35/13-05V 30 Hesketh Street  
Chevy Chase Village Historic District

**HISTORIC PRESERVATION COMMISSION STAFF REPORT**

<b>Address:</b>	30 Hesketh Street, Chevy Chase	<b>Meeting Date:</b>	10/12/2005
<b>Applicant:</b>	Beverly & Robert Haller (David Vogt, Agent)	<b>Report Date:</b>	10/5/2005
<b>Resource:</b>	Contributing Resource Chevy Chase Village Historic District	<b>Public Notice:</b>	9/28/2005
<b>Review:</b>	HAWP	<b>Tax Credit:</b>	None
<b>Case Number:</b>	35/13-05V	<b>Staff:</b>	Michele Oaks
<b>PROPOSAL:</b>	Side Addition	<b>RECOMMENDATION:</b>	Approval with condition

SUBJECT: Historic Area Work Permit # **398329 and 398330** for addition and entry stoop alterations

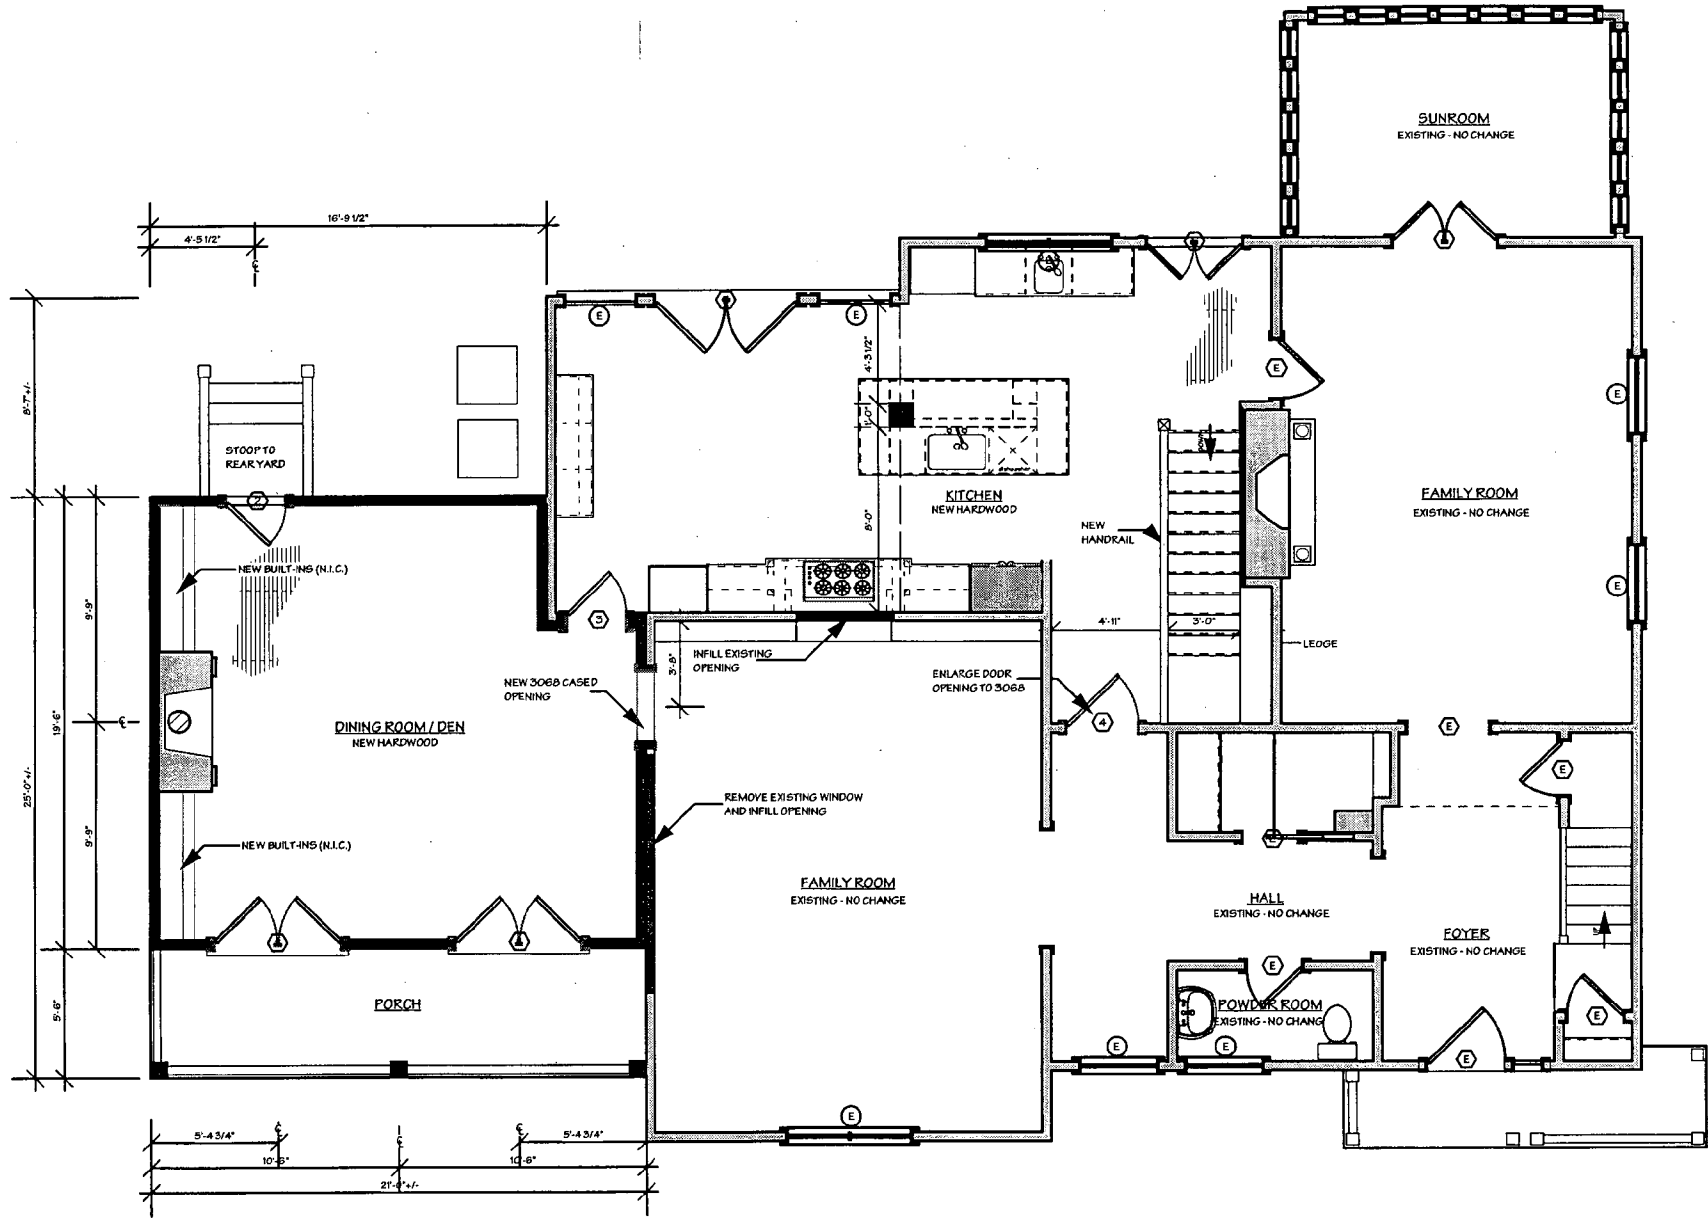
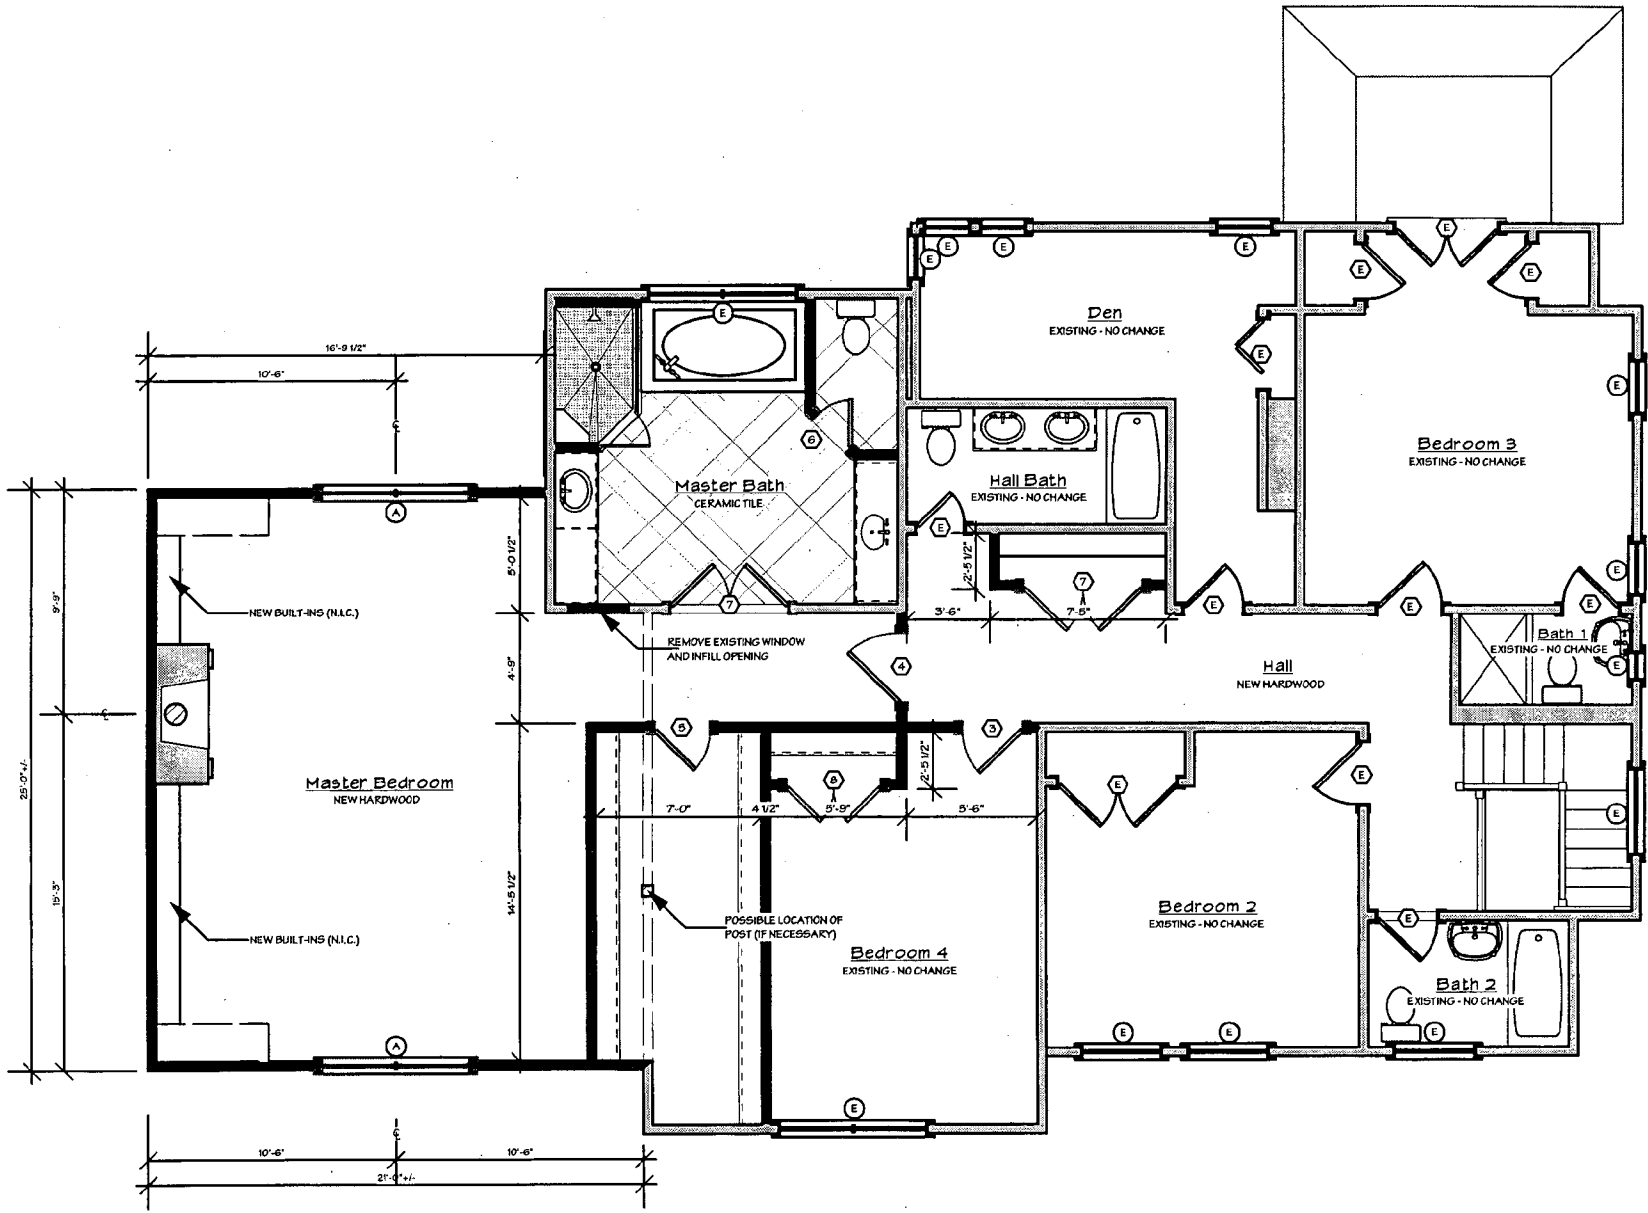
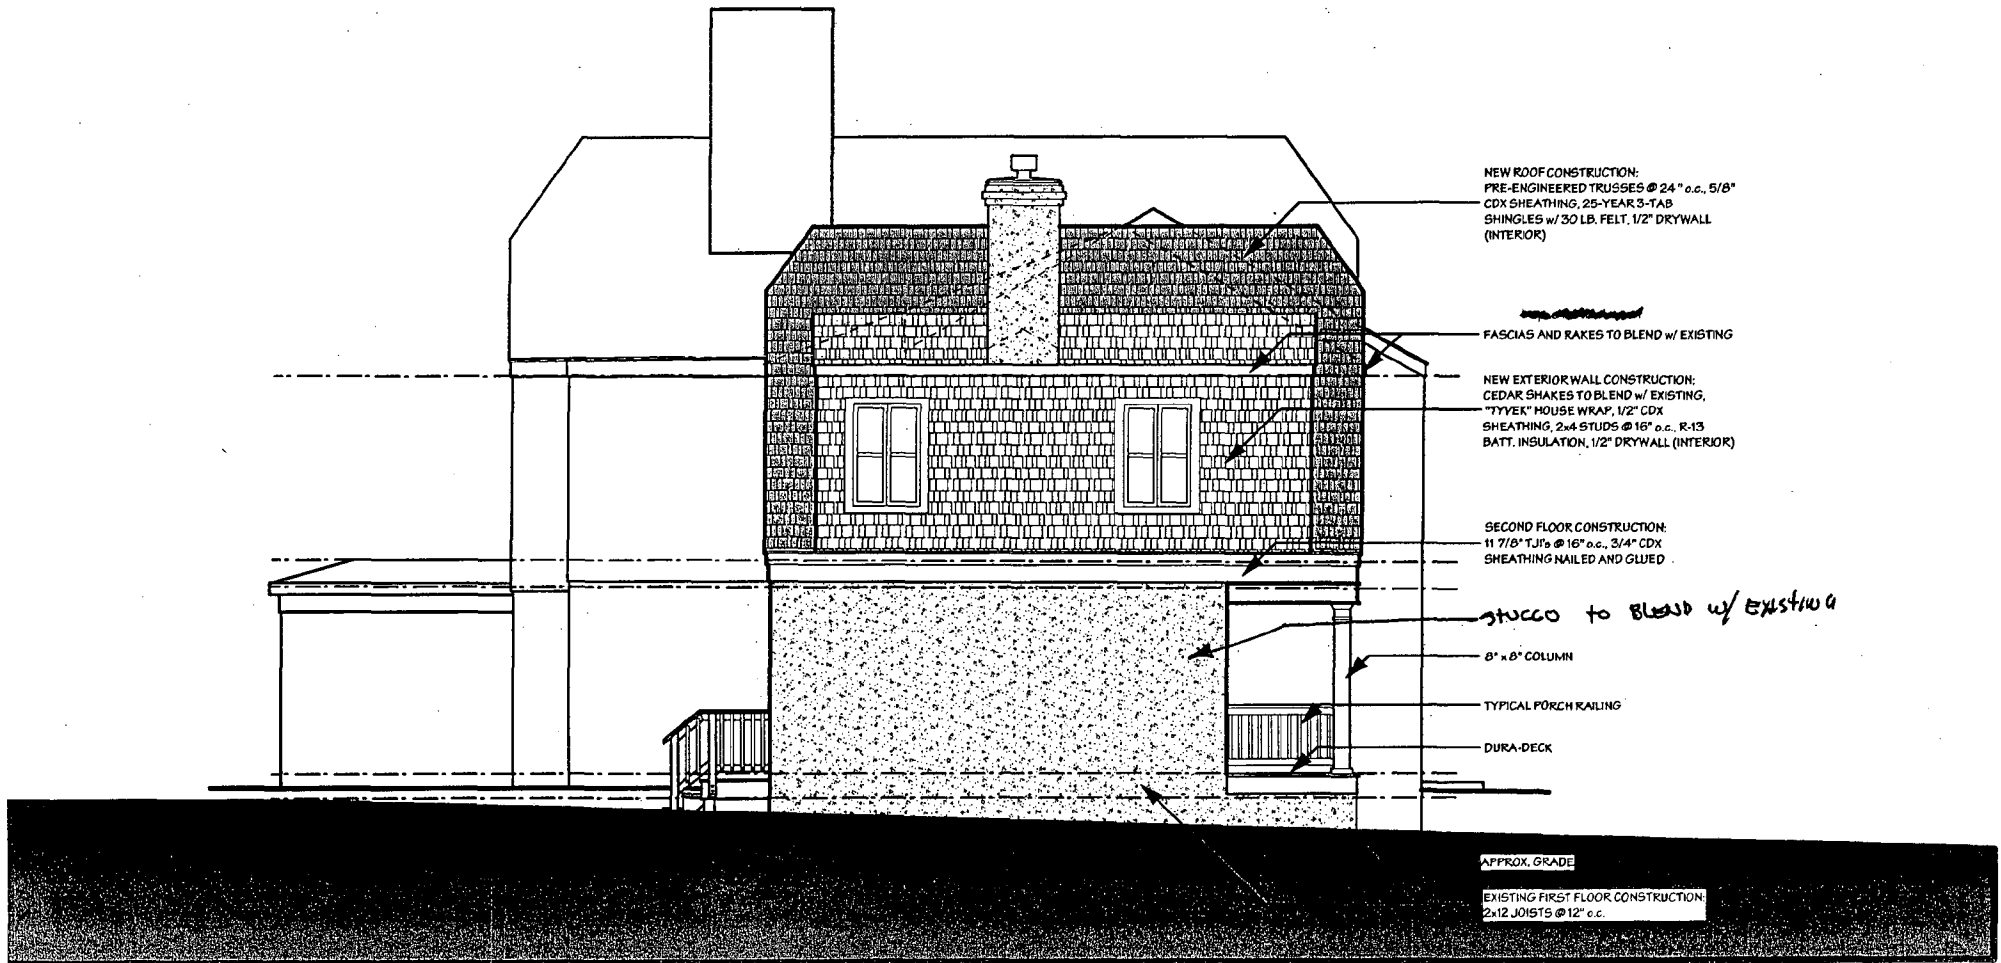
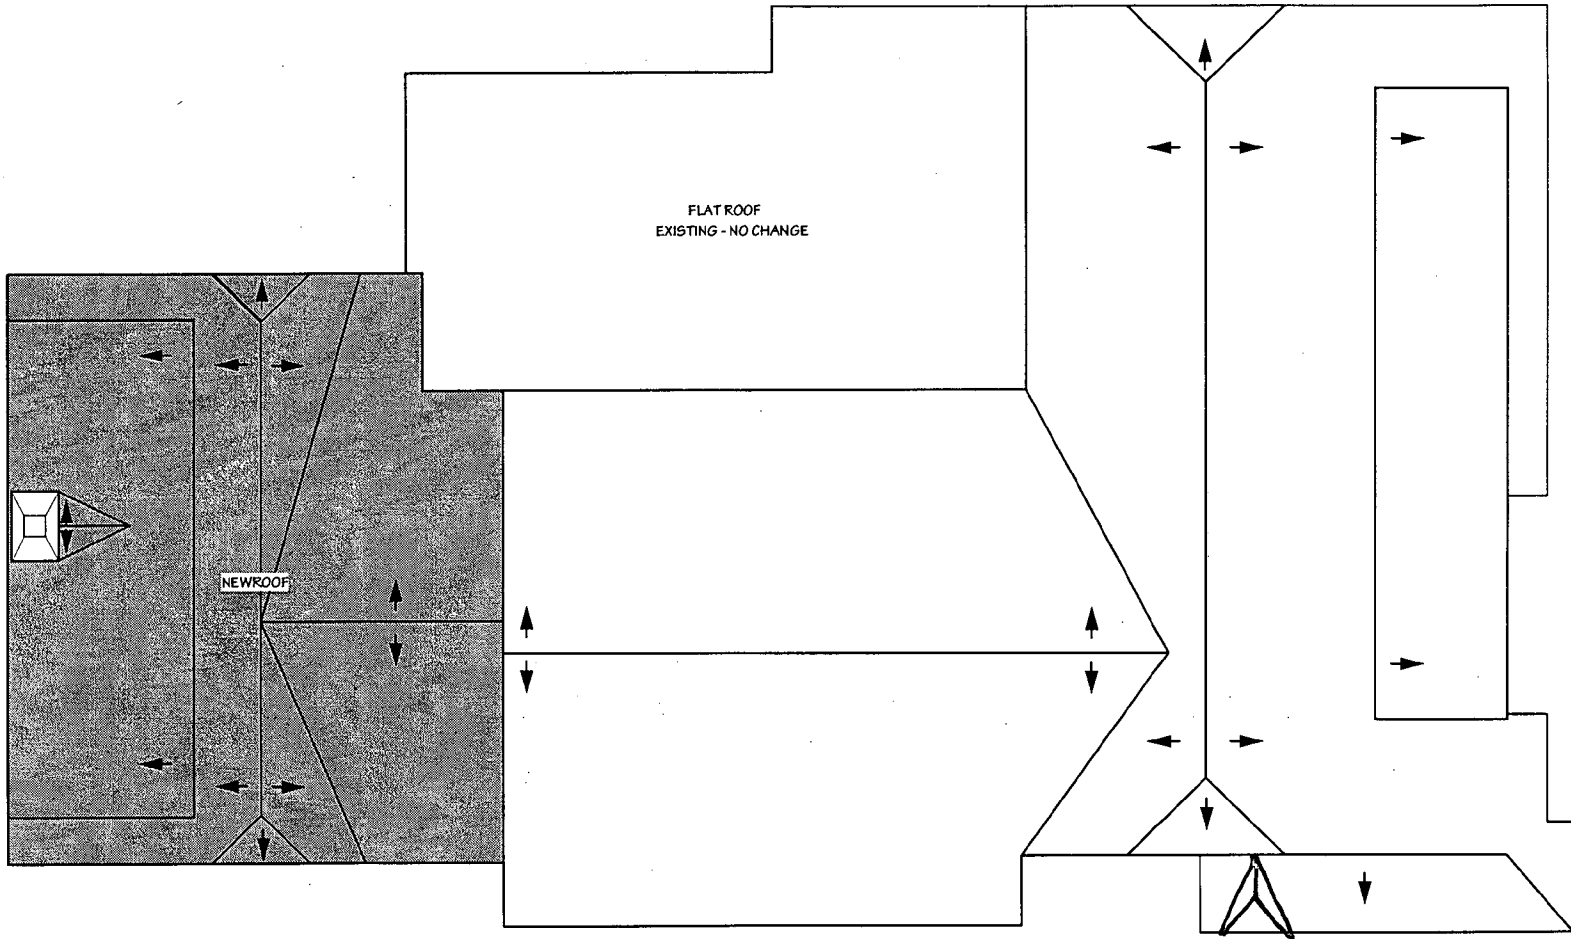
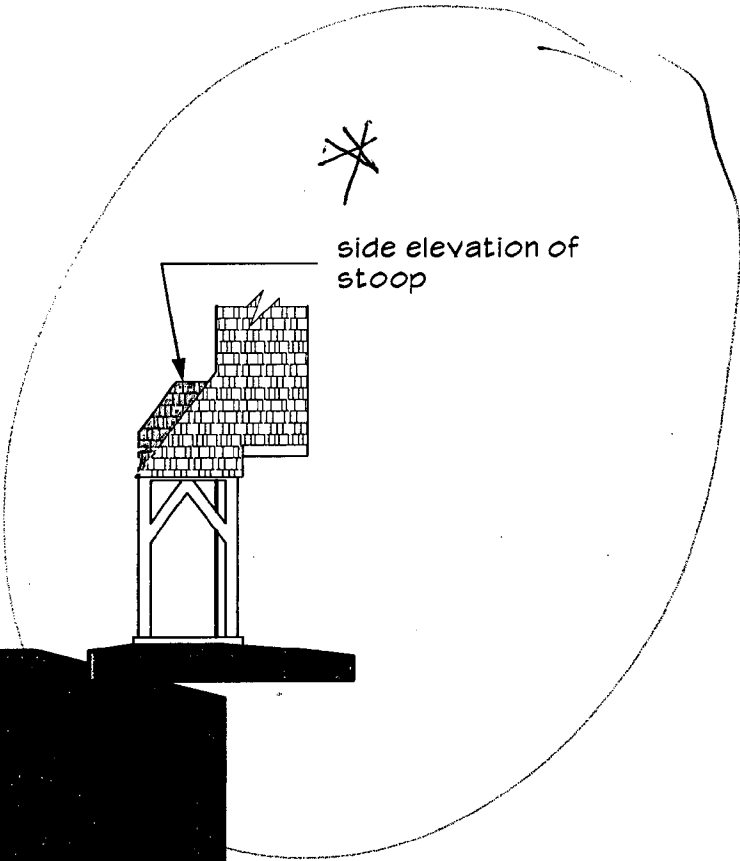
The applicant and their designer were before the Commission at the October 12<sup>th</sup> public hearing. At this meeting, the Commission was concerned with the roof height detail in drawings that were shown in front elevations and not conveyed in the side elevation. Additionally the Commission wanted to see some modifications in the plans, which included:

- Installation of windows in the left elevation.
- A change of the chimney on the addition from siding to stucco or masonry and detailed with corbelling.
- Lower the ridgeline of the addition.
- Draft a roof plan.
